# SERVICEINFORMATION

### **ADAPTER CABLE 4.07360.53.0**

## FOR REPLACING PREDECESSOR VERSIONS WITH THE LATEST EXHAUST BACK PRESSURE SENSORS

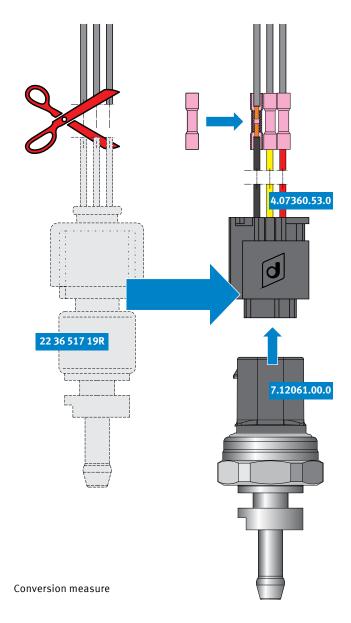
The exhaust back pressure sensor with ref. no. 22 36 517 19R has been discontinued. This sensor was used in Renault engines. In some cases, the affected engines were also installed in Mercedes-Benz, Nissan and Dacia vehicles (see table on the back). As OE, the exhaust back pressure sensor has been replaced with a sensor that has a different connector plug. As a result, if this old, discontinued sensor fails, the original plug must be removed and replaced with a suitable one.

To make it easier to replace the part, Motorservice offers the adapter cable 4.07360.53.0, which enables the discontinued exhaust back pressure sensor to be easily replaced with the suitable model 7.12061.00.0 from Pierburg.

- Cut off the old sensor 223651719R close to the old plug.
- Connect the adapter cable 4.07360.53.0 using the shrink-fit connectors, making sure to observe the pin assignment.
